**Subject:** Response to U.S. EPR Design Certification Application RAI No. 555 (6611), FSAR Ch. 7, Supplement 1

**Subject:** Response to U.S. EPR Design Certification Application RAI No. 555 (6611),  
FSAR Ch. 7, Supplement 2  
**Sent Date:** 2/21/2013 2:54:28 PM  
**Received Date:** 2/21/2013 2:54:48 PM  
**From:** WILLIFORD Dennis (AREVA)

**Question 07.01-54:****Open Item****Follow up to RAI 505, Question 07.01-46**

**Question 07.01-55:****Open Item****Follow up to RAI 505, Question 07.01-46**

Figure 7.1-2—Distributed Control System Functional Architecture

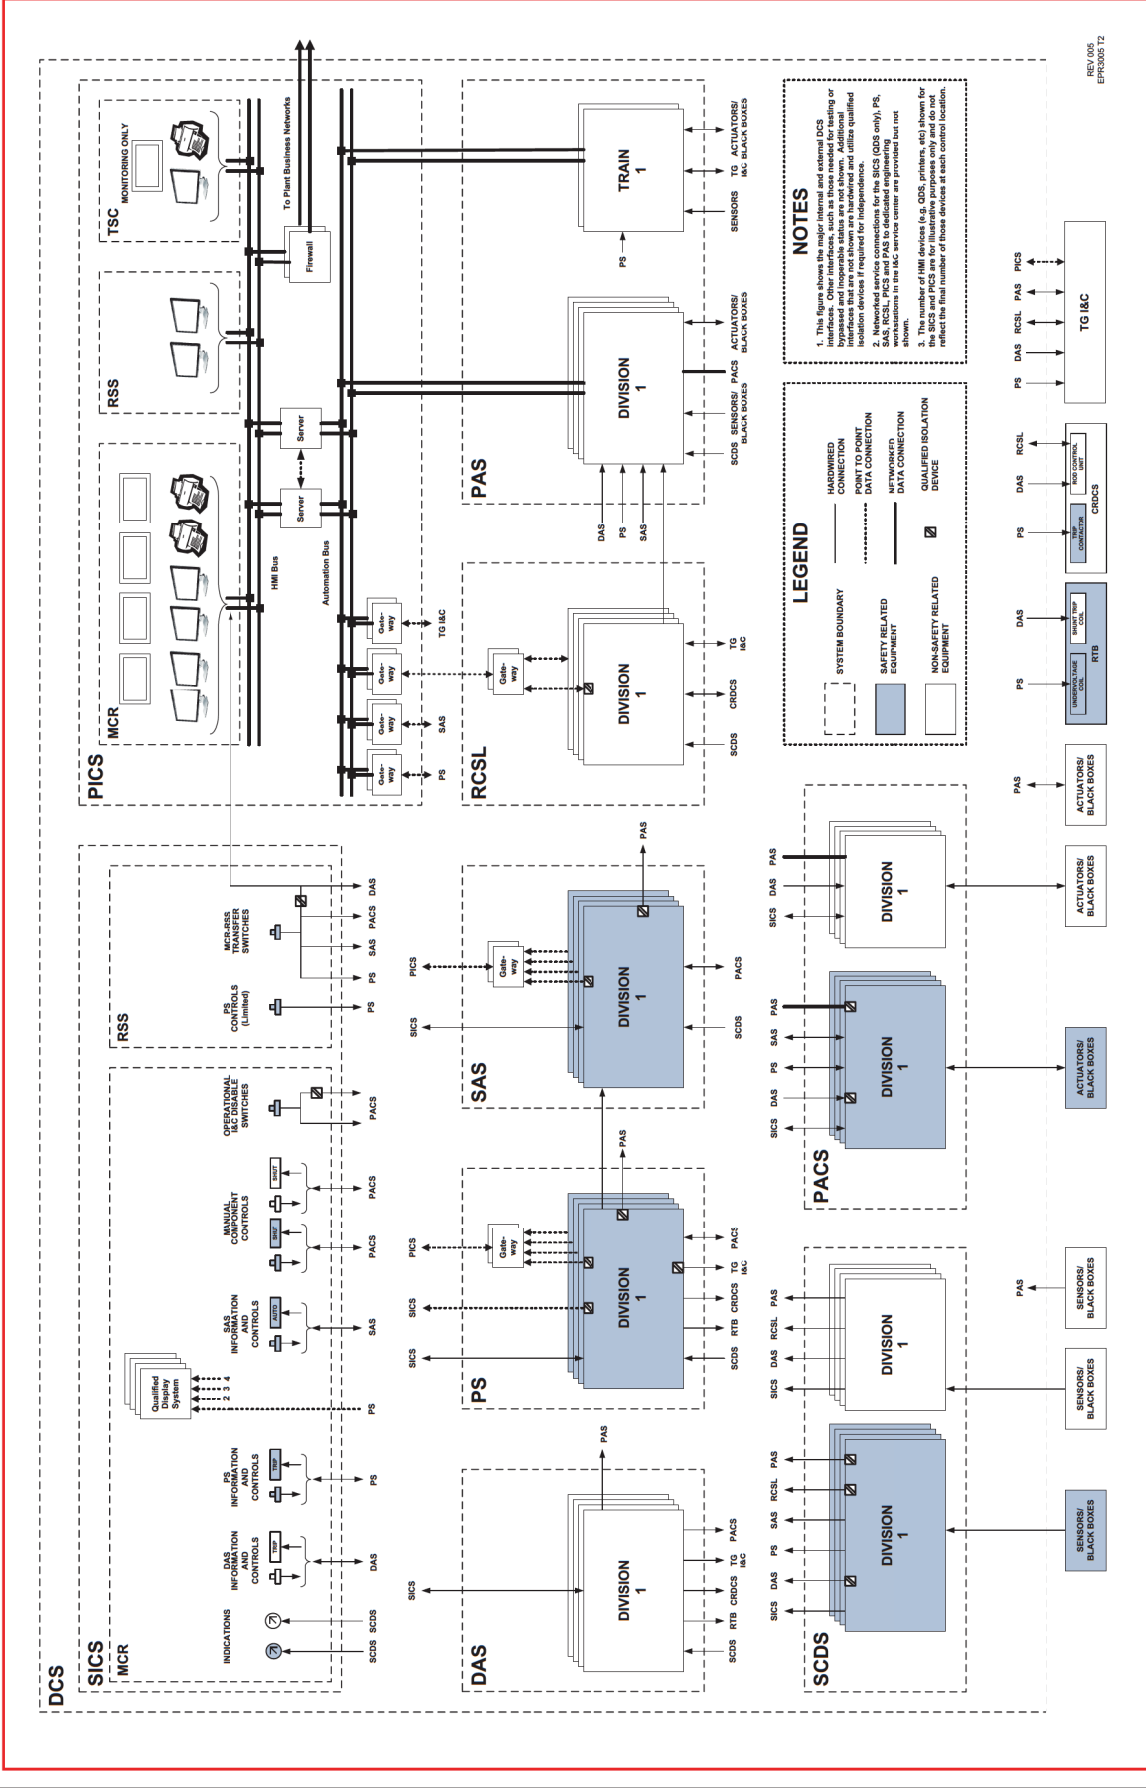
U.S. EPR FSAR Tier 2, Figures 7.1-2, 7.1-6, and 7.1-8, will be revised to show a bi-directional hardwire signal between the PS and PACS.

Figure 7.1-21—PACS Priority Module Logic Diagram  
Sheet 1 of 2

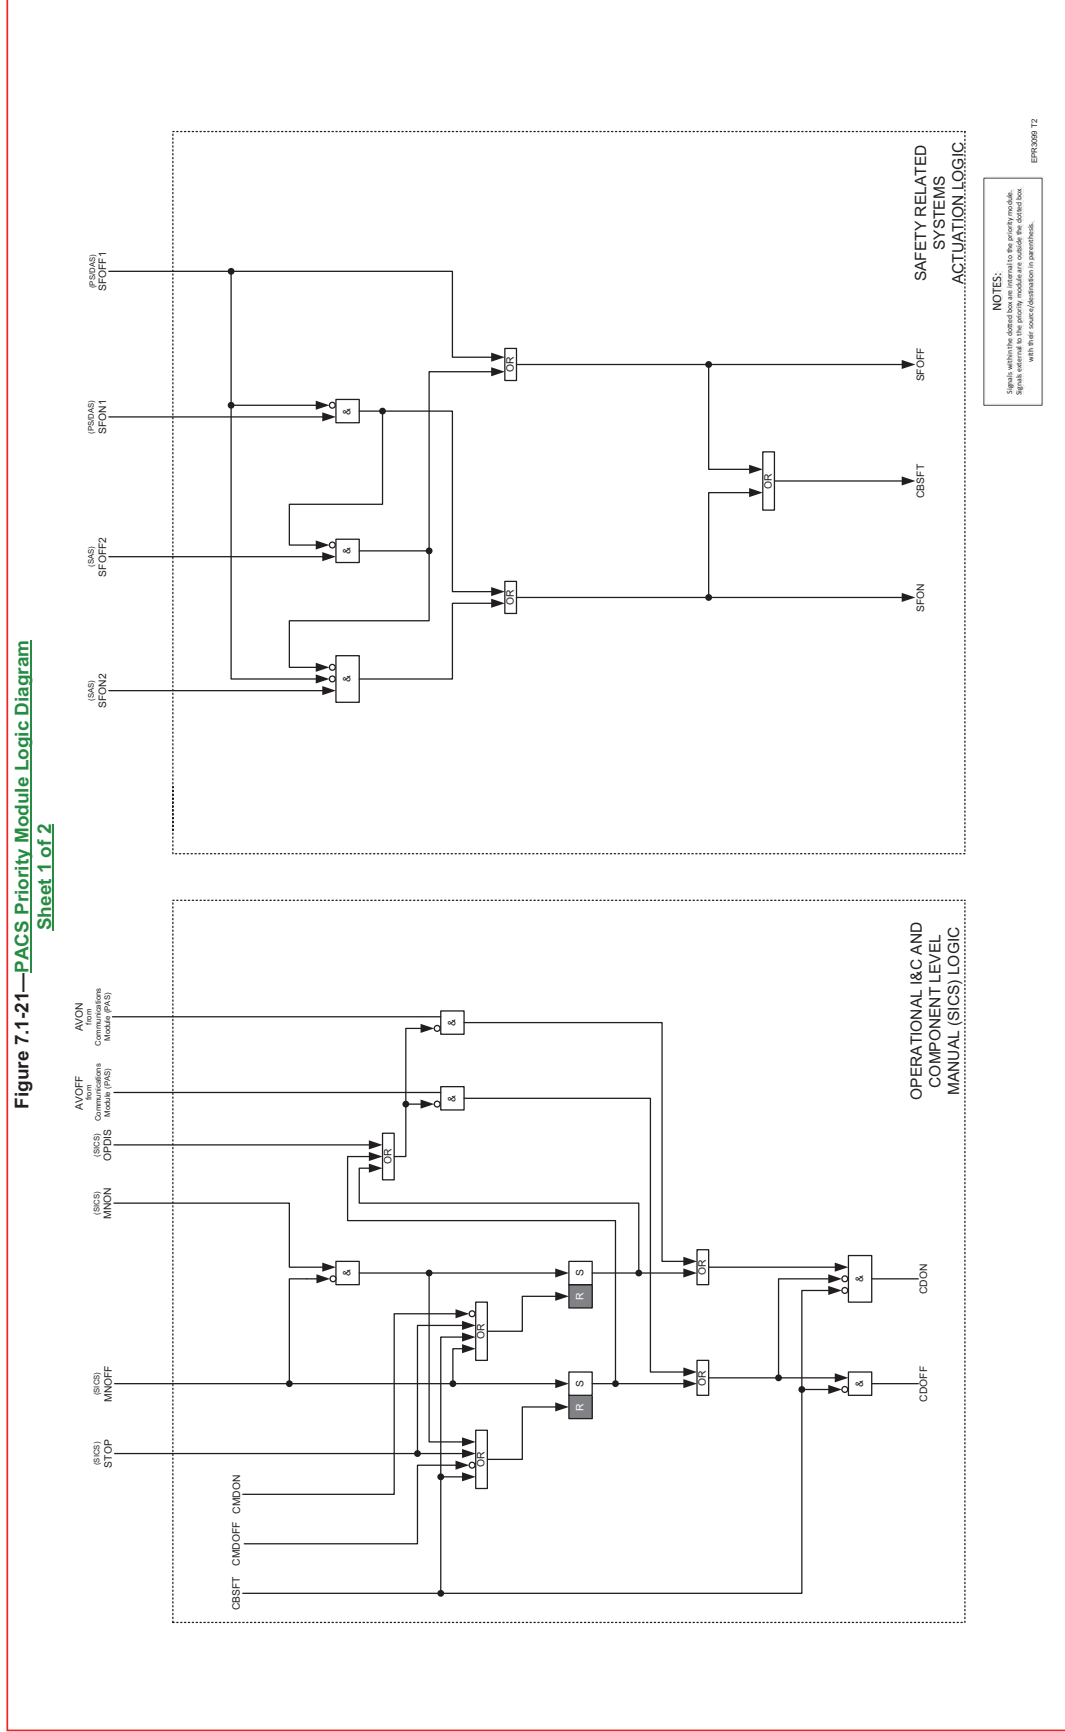
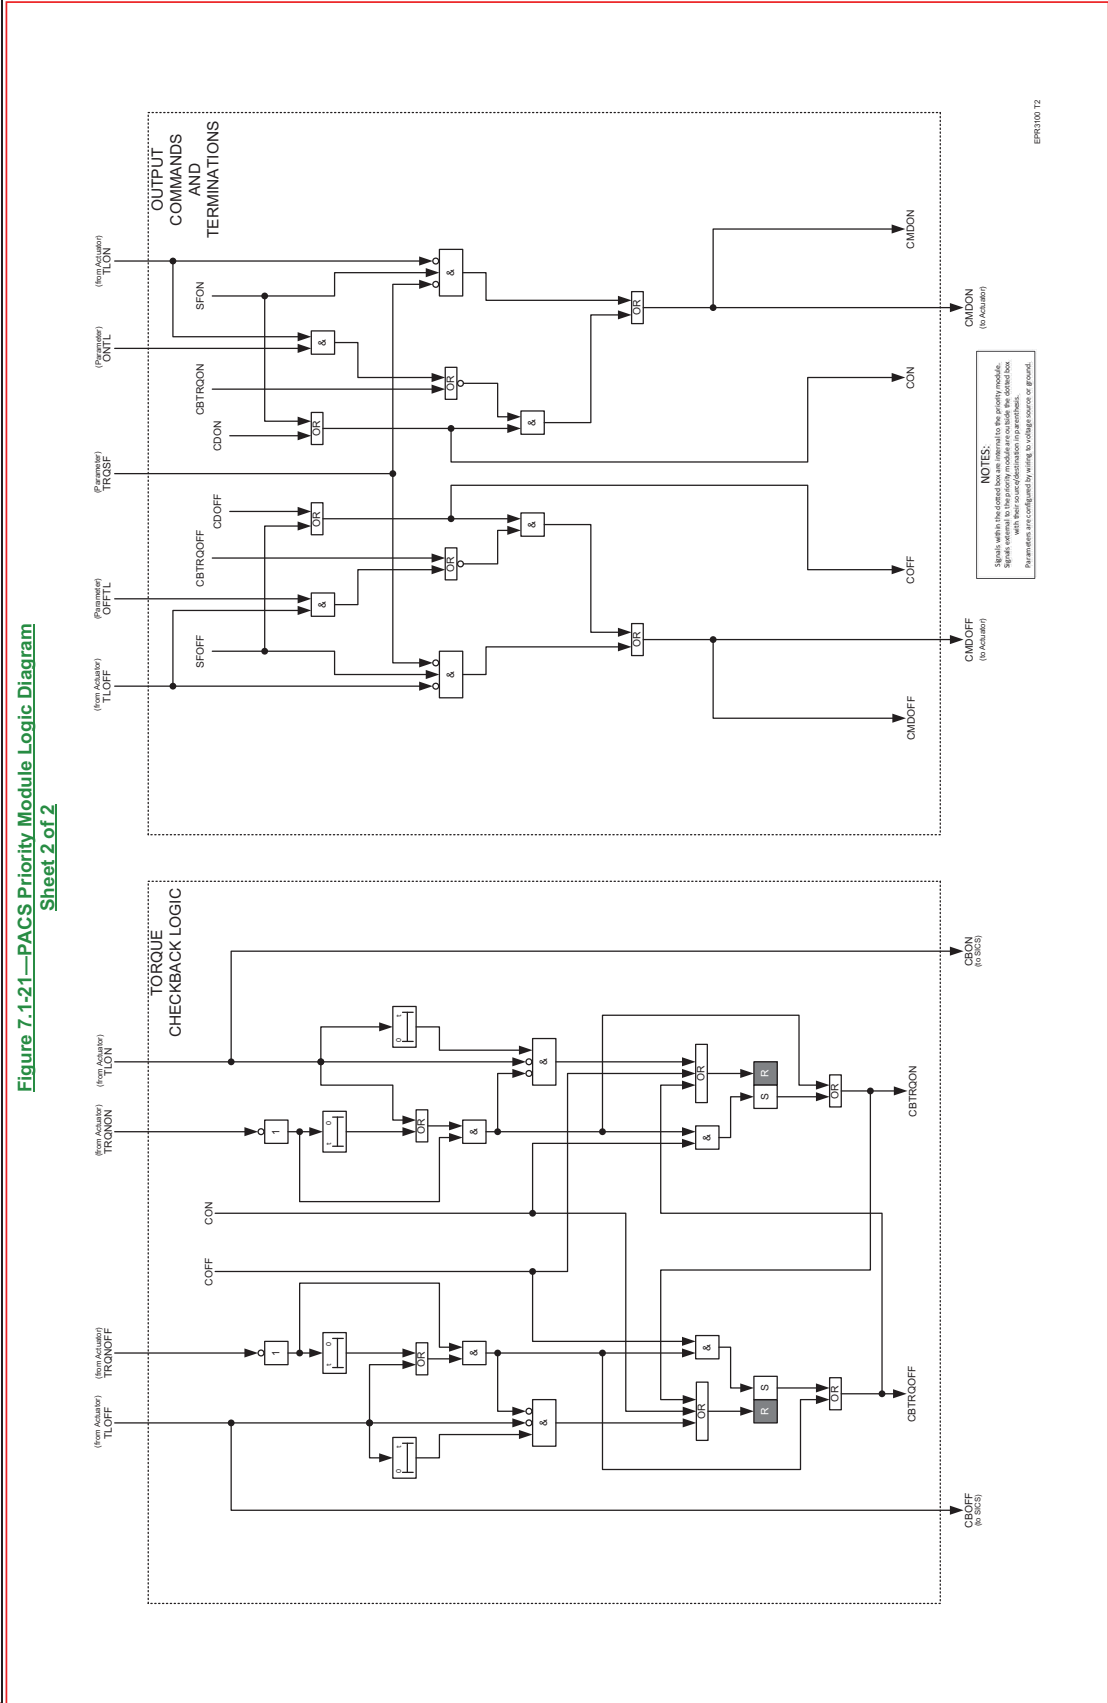
4. These definitions for latched and unlatched should not be applied generically to all interfacing I&C systems. The priority module logic diagram (U.S. EPR FSAR Tier 2, Figure 7.1-21 (Sheets 1 and 2)), shows which inputs are latched (through the use of the Memory logic block), nonlatched (no use of the Memory logic block), and delayed (through the use of Time Delay logic blocks). The priority module logic diagram (Figure 7.1-21 (Sheets 1 and 2)) shows how a signal may be unlatched in the PACS.
5. The EFWS actuation function is latched and unlatched both automatically and manually. The pulse duration is used to initiate the EFWS actuation on SIS and LOOP from the PS; then the signal is removed so the SAS EFWS SG level control function can have priority and control the EFWS level control valve.

The priority module logic diagram (U.S. EPR FSAR Tier 2, Figure 7.1-21 (Sheets 1 and 2)), shows how latched inputs (through the use of the Memory logic block), nonlatched inputs (no use of the Memory logic block), and delayed inputs (through the use of Time Delay logic blocks) are used to provide logic for prioritization.

Other systems do not have the priority to interfere and overload the EDG. As shown in the priority module logic diagram (U.S. EPR FSAR Tier 2, Figure 7.1-21 (Sheets 1 and 2)), OFF has higher priority than ON; therefore, any signals from other systems to turn on these components will have lower priority than a PS OFF signal and will be ignored. The ESW and CCW pumps are started by the PS as part of the load sequence so that both systems' pumps are not turned on at the same time and potentially overload the EDG. Therefore, other systems cannot turn on both systems' pumps at the same time because the PS has the highest priority and already properly started them sequentially as part of the loading sequence.

3. Blocking of the PAS commands is done by the PACS module. Once the OPDIS switches provide 2-out-of-4 vote signal, this is sent to the priority module of the PACS. The priority module of the PACS, upon receiving the OPDIS signal, blocks the actuation inputs from the communication module. This prevents the PAS from actuating a safety-related component. See the logic diagram for the PACS priority module (U.S. EPR FSAR Tier 2, Figure 7.1-21 (Sheets 1 and 2)) to see the OPDIS input interface.

Figure 7.1-30—Operational I&C Disable Switch Configuration

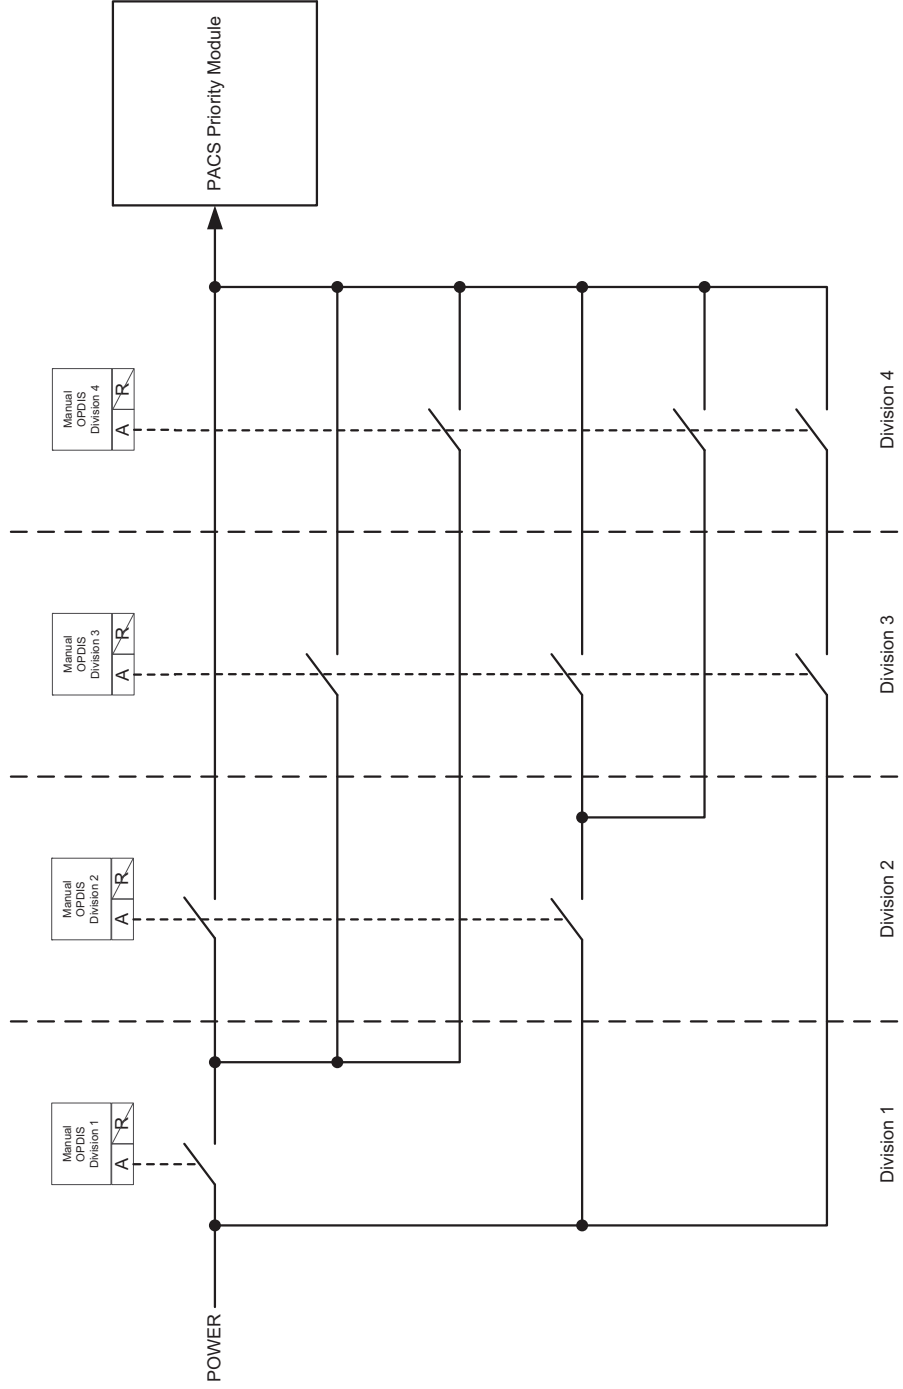
- d-4. In terms of the 2oo4 voting logic in the OICS: (i) Does this take place within the PS? (ii) Is this hardwired logic? (iii) Does the applicant have a figure that demonstrates this voting configuration for the staff’s review?
